UKWIN COMMENTS ON ENZYGO RESPONSE OF 13TH JULY 2021

Energy from Waste Facility

Hownsgill Industrial Park, Templetown, Consett

DM/20/03267/WAS

Figure 16. Converting to CHP or biostabilisation technologies lowers the GHG emissions of waste management facilities

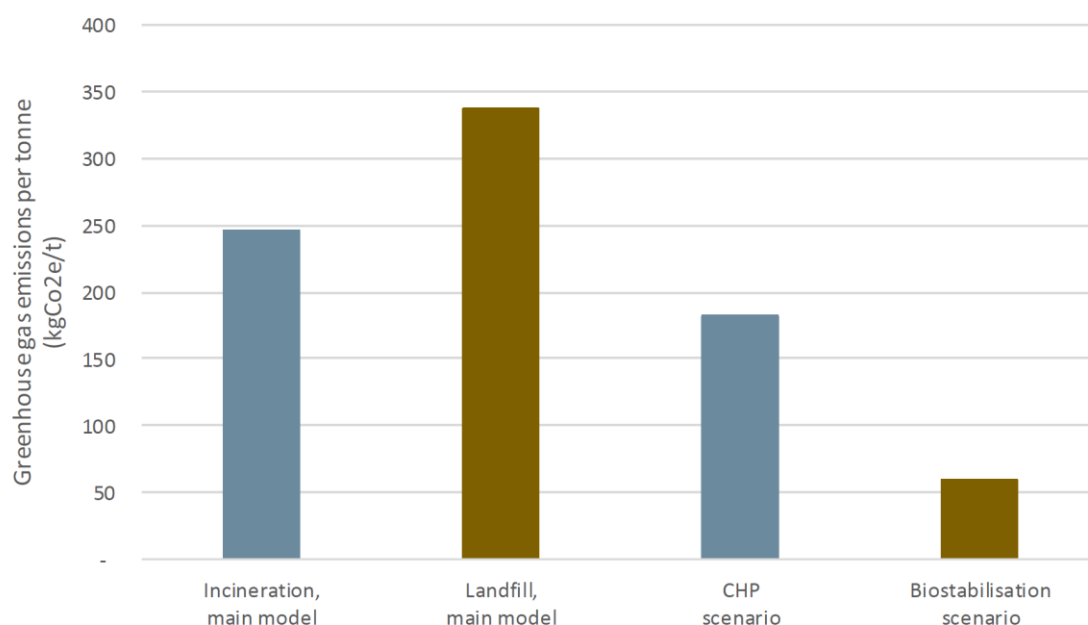
33. The applicant also overlooks the fact that the ZWS report makes clear that when bio-stabilisation is taken into account landfill has significantly lower emissions than incineration, as depicted in Figure 16 of the ZWS report (reproduced below).

34. In the supporting text below Figure 16 ZWS explains how:

"Figure 16 also shows a comparison to the potential savings from reducing biodegradable material to landfill. This could be achieved using biostabilisation. If levels of biogenic carbon can be reduced from 15% to 5% of residual municipal waste, landfill impacts would fall from 337 kgCO₂e/t to 59 kgCO₂e/t."
